MARK	DATE	DESCRIPTIONS	BY	CH'D	CCO#
1	06/14/11	TOWER BOOM BEARINGS	CC	MN	128S1
0	10/30/09	TOWER MAINTENANCE ENHANCEMENTS	JC	MN	128

SAN FRANCISCO OAKLAND BAY BRIDGE
EAST SPAN SEISMIC SAFETY PROJECT
SELF-ANCHORED SUSPENSION BRIDGE
(SUPERSTRUCTURE & TOWER)

TOWER ACCESS DETAILS NO. 16B

TOWER ACCESS DETAILS NO. 16D

SECTION M-M
1:5
(Bottom Bronze PL shown, top Bronze PL similar)

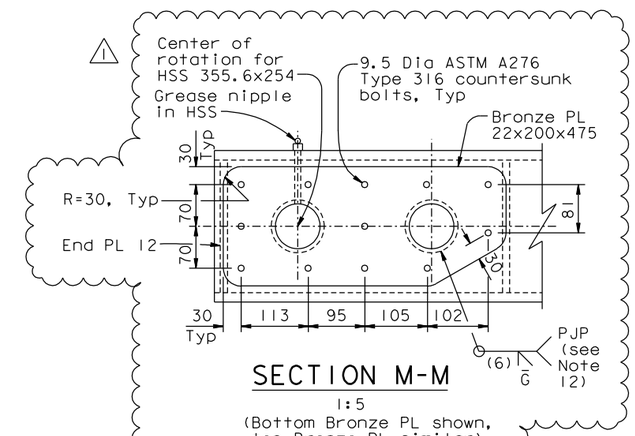
MARK	DATE	DESCRIPTIONS	BY	CH'D	CCO#
1	06/14/11	TOWER BOOM BEARINGS	CC	MN	128S1
0	10/30/09	TOWER MAINTENANCE ENHANCEMENTS	JC	MN	128

DETAIL J
1:5

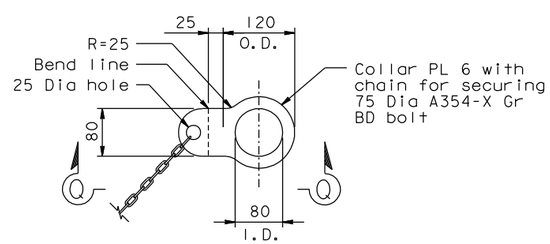
1. The exterior pipe sleeve shall be placed to bear on the flanges of W460. Adjust thickness of neoprene strips as needed.
